RE: GRU Comments on Beazer Comprehensive Groundwater Monitoring and Sample Analysis Plan (October 8, 2008)

**TO:** Rick Hutton  
**FROM:** DNAPL Team  
**DATE:** December 3, 2008  
**XC:**  
**RE:** Comments on Beazer Comprehensive Groundwater Monitoring and Sample Analysis Plan dated October 8, 2008

The GRU DNAPL Team offers these comments and observations to the Comprehensive Groundwater Monitoring and Sample Analysis Plan (CGMSAP) dated October 8, 2008.

Figure 1. Temporal fluctuation in groundwater elevations measured in standard-completion monitoring wells.

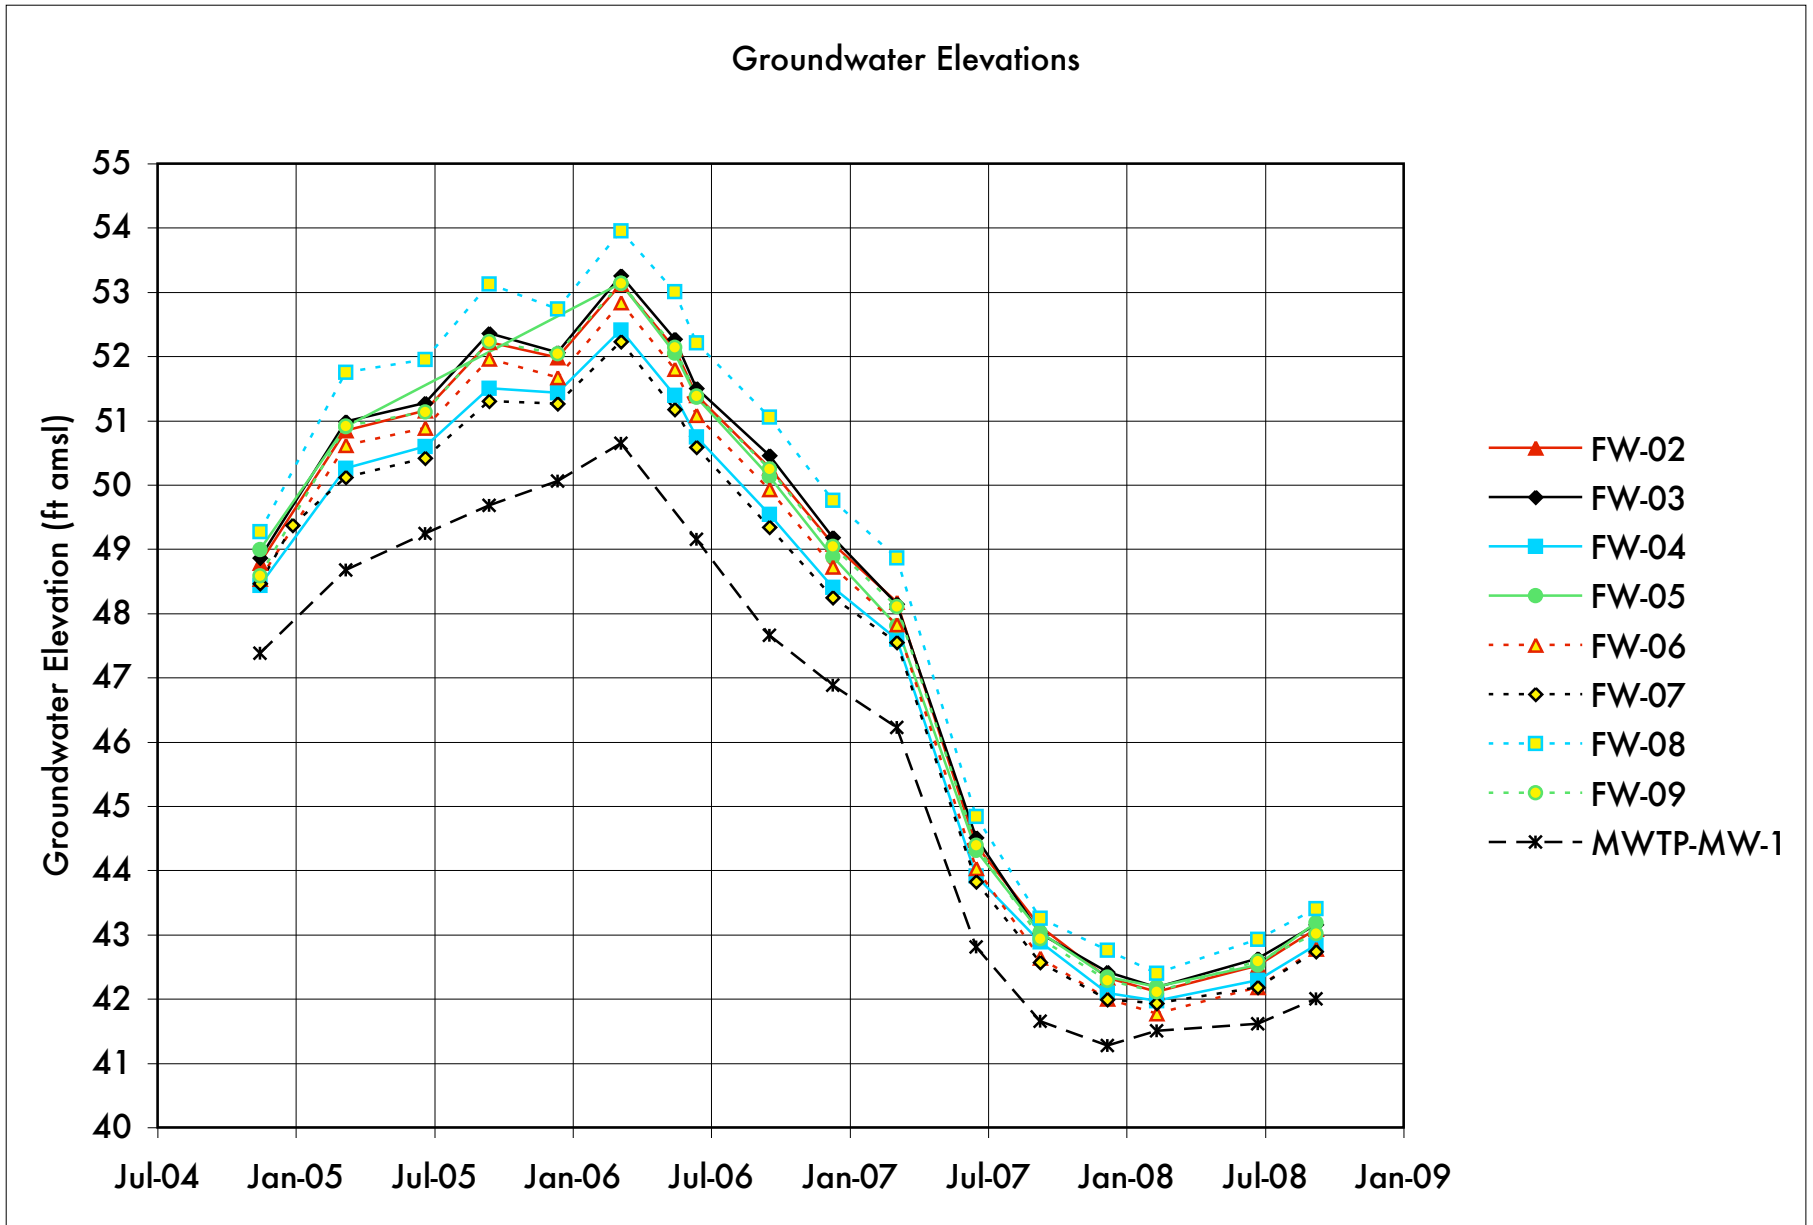
Groundwater elevations measured in the standard wells have fluctuated by as much as 10 feet to 11 feet (see attached Figure 1) based on quarterly monitoring from 2006 to 2008 and there could be site-scale changes in groundwater flow direction associated with such fluctuations. Continued monitoring of these wells on a quarterly frequency, at least, will be necessary to identify changes in groundwater flow direction that might be the cause of changes in groundwater chemistry observed at any given location.

Although there are more multi-port system wells than the standard-completion monitoring wells in the Floridan Aquifer, the pattern of groundwater elevations from the multi-port wells is more variable in indicated flow direction than the general southwest-northeast pattern exhibited from the standard wells. It is not clear whether which pattern is more representative of conditions in the aquifer. Monitoring of both types of wells should continue as part of the CGMSAP.

Figure 2. Comparison of temporal fluctuations in naphthalene concentrations in FW-6 with the fluctuations in cross-site hydraulic gradient estimated between FW-08 (southwest) and FW-07 (northeast).

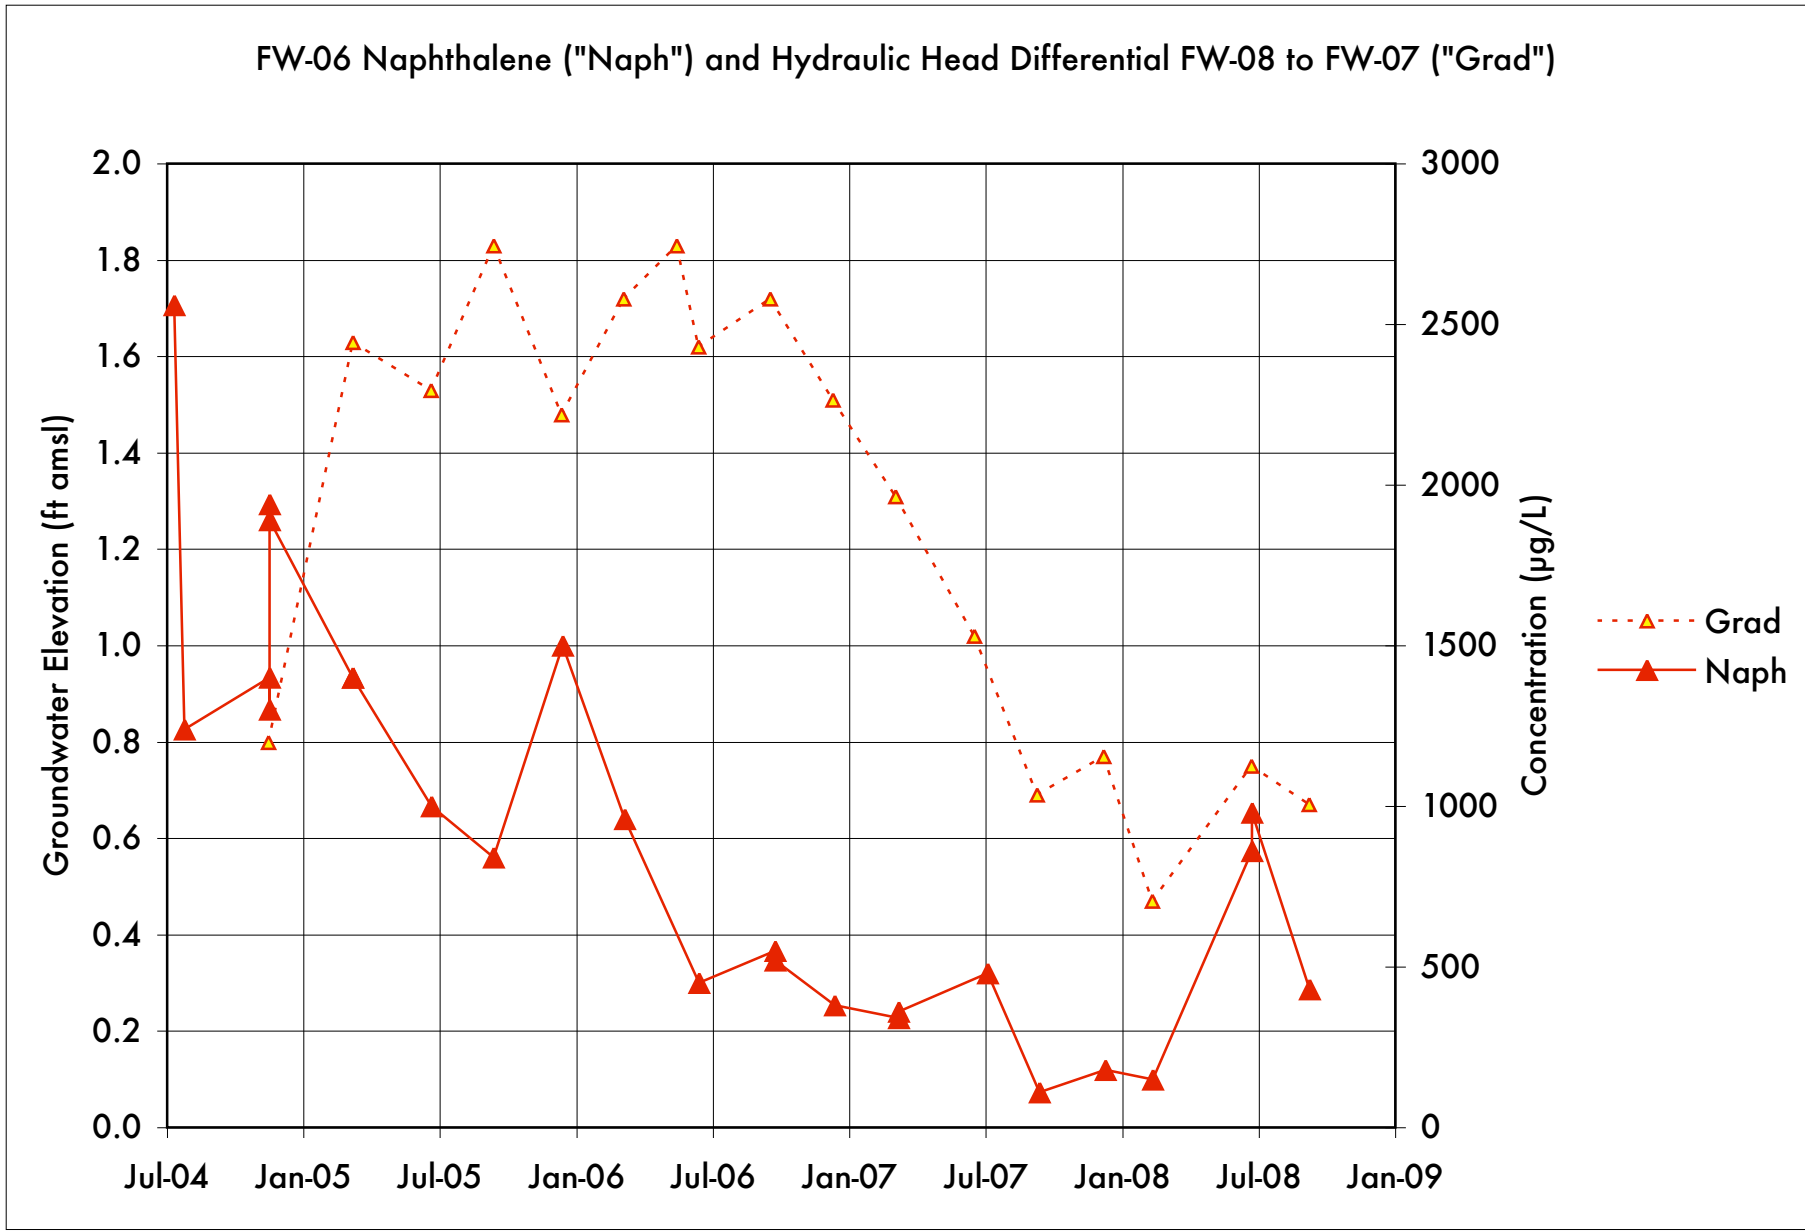
FW-6 should be retained – for sampling and recording groundwater levels – during and after the “pumping test”. Concentrations of Naphthalene show a general increasing trend between September 2007 (110 ug/L) to the June 2008 reported concentrations of 860 ug/L and 980 ug/L (duplicate samples in June 2008). The Sept 2008 sample contained 430 ug/L Naphthalene. The trend of Naphthalene concentrations in well FW-6 generally mirrors the trend in groundwater gradient across the site - see attached Figure 2).

Figure 3: Selected Monitor Wells Referenced in Discussion of Surficial Aquifer - Issue #3

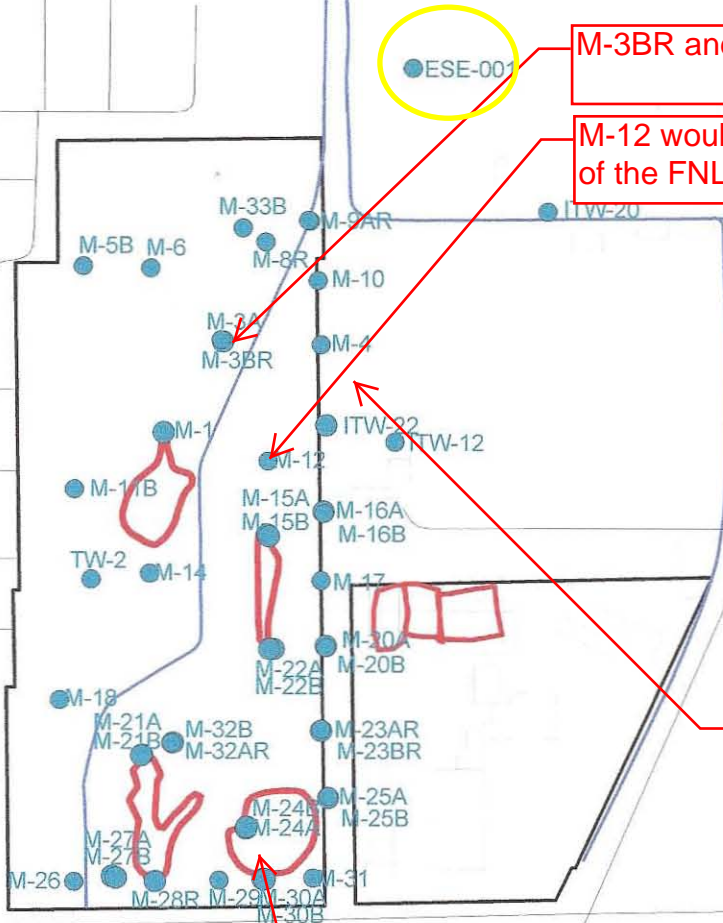
Well PW-1 in the Former Process Area should be included in the CGMSAP as a well to be sampled. For some time this well produced DNAPL. A contact-water sample can be analyzed to determine what this particular source is comprised of. Other Surficial Aquifer monitor wells that should be included - in order to provide regular information on the status of the groundwater quality in the Surficial Aquifer - are M-1 [Former North Lagoon], M-3BR [northeast of the Former North Lagoon], M-12 [Former Drip Track], ESE-001 [off-site to the northeast] and a replacement well for ITW-21. Please see attached Figure 3 that shows the locations of these

monitor wells. We see no reason to continue monitoring ITW-12 and -22, once ITW-21R has been installed.

M-3BR and ESE-001 should be monitored

M-12 would provide a useful data set for cleanup of the FNL

Replacement well needed for ITW-21.  
Neither ITW-22 nor ITW-12 are contaminated in the sense that ITW-21 was contaminated with 5570 ug/L naphthalene in Feb 2004

PW-1, DNAPL well should be monitored
